COMAL COUNTY

Permit of Authorization to Construct an On-Site Sewage Facility Permit Valid For One Year From Date Issued

Permit Number: 118235
Issued This Date: 04/28/2025
This permit is hereby given to: SQR DEVELOPMENT LLC

Comal County Comments Response

670 (Lot 501) Valley Ridge
Canyon Lake, TX
Comal County

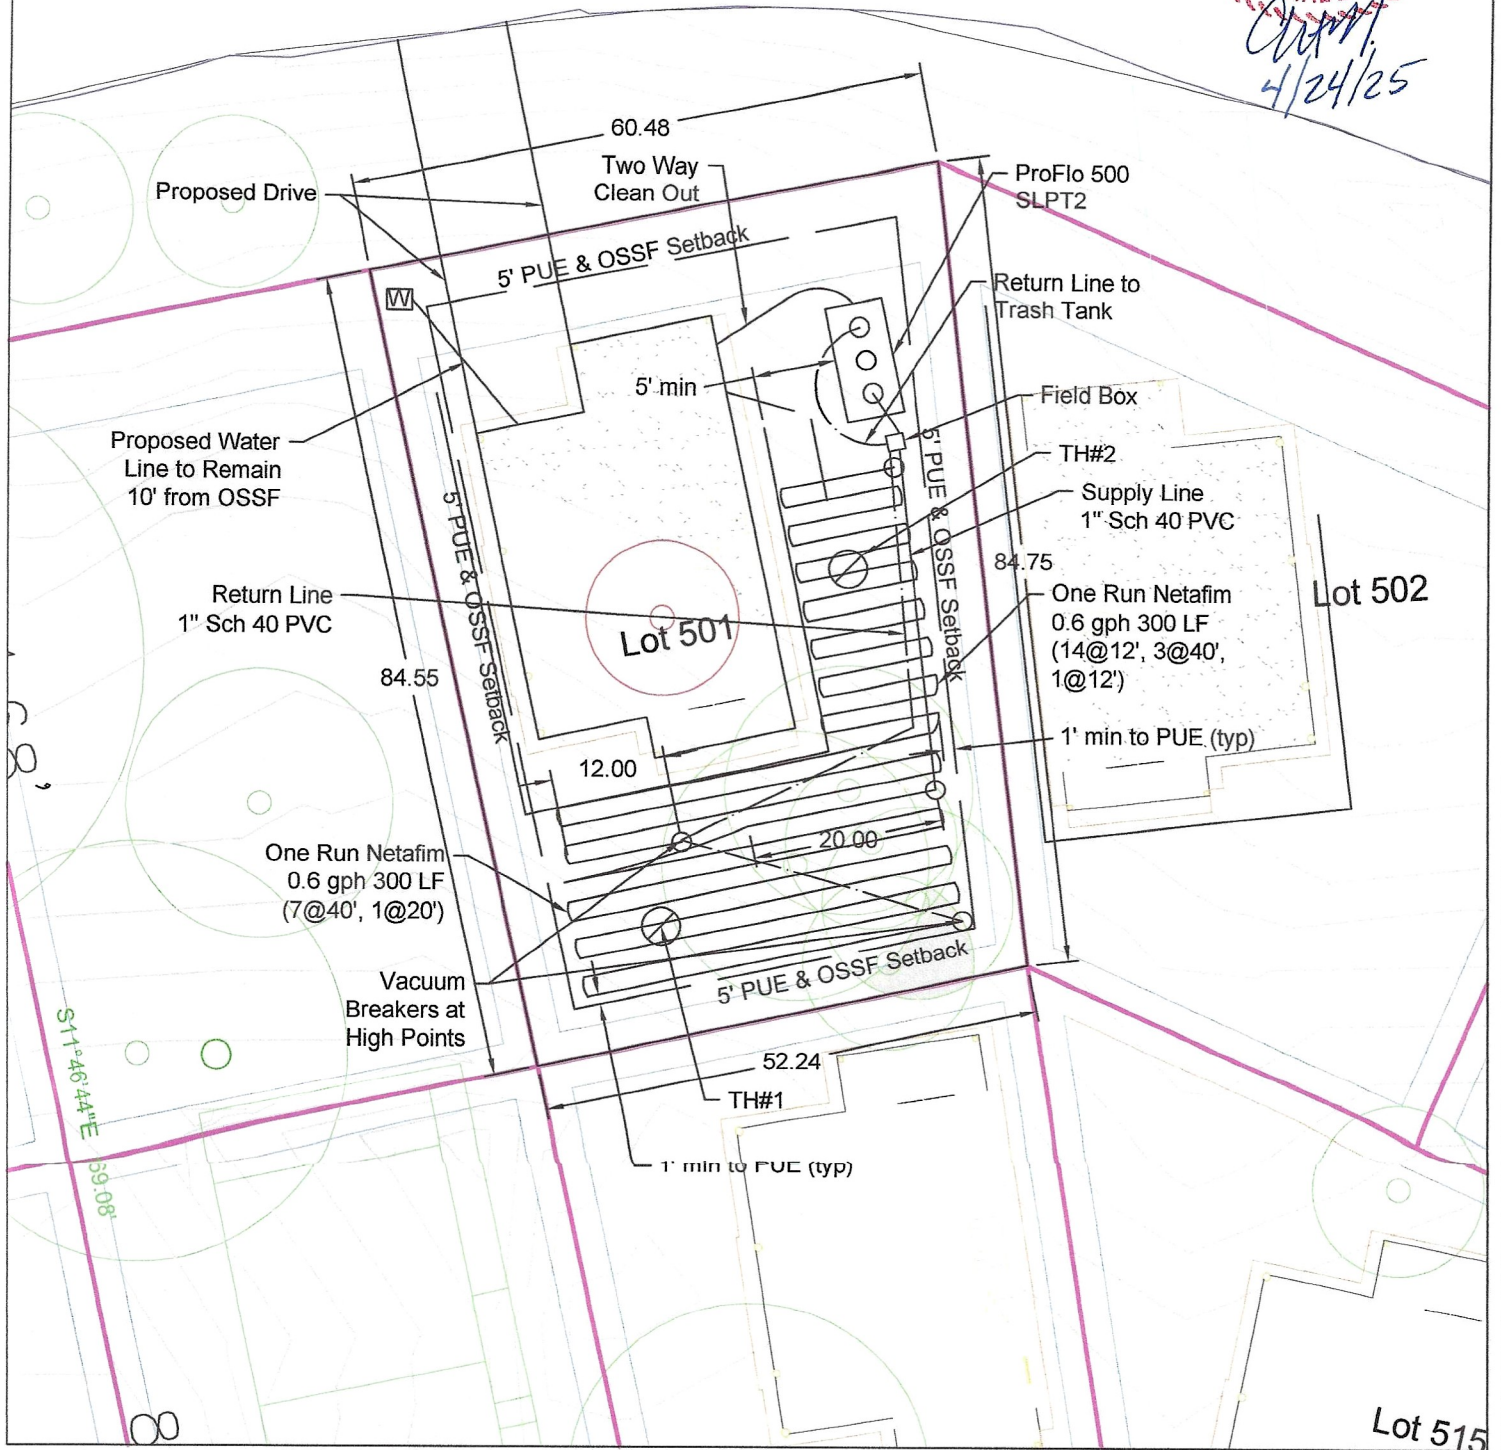
- ✓ 1. The maintenance provider must certify that the signature on the maintenance contract is his true signature.
2. Physical address of maintenance provider needed on the maintenance contract.
3. The maintenance contract must indicate that the start date of the contract is the date the "License to Operate" is issued (not LTO).
4. The maintenance contract must indicate a maintenance schedule in accordance with state regulations, it must also provide the required minimum number of service visits for the 2 year period (8 over 2 years).
- ✓ 5. Identify 1 ft. setback from the edge of the drip system to the utility easement.
6. Revise as needed and resubmit.

- ✓ 5. **A different property owner is indicated within the planning materials.**
- ✓ 6. **Clearly outline the location of the home/improvements.**
7. **Identify utility easements on the design.**

- ✓ 8. **Identify the separation distance from the OSSF components to the property lines.**
- ✓ 9. **Show test hole locations on the design.**
- ✓ 10. **A preliminary inspection is scheduled for tomorrow. Additional comments may be necessary when complete.**

- 1) The maintenance provider must certify that the signature on the maintenance contract is his true signature.
[The maintenance contract has been updated.](#)
- 2) Physical address of maintenance provider needed on the maintenance contract.
[The maintenance contract has been updated.](#)
- 3) The maintenance contract must indicate that the start date of the contract is the date the "License to Operate" is issued (not LTO).
[The maintenance contract has been updated.](#)
- 4) The maintenance contract must indicate a maintenance schedule in accordance with state regulations, it must also provide the required minimum number of service visits for the 2 year period (8 over 2 years).
[The maintenance contract has been updated.](#)
- 5) Identify 1 ft. setback from the edge of the drip system to the utility easement.
[A one-foot setback is now shown.](#)
- 6) Revise as needed and resubmit.
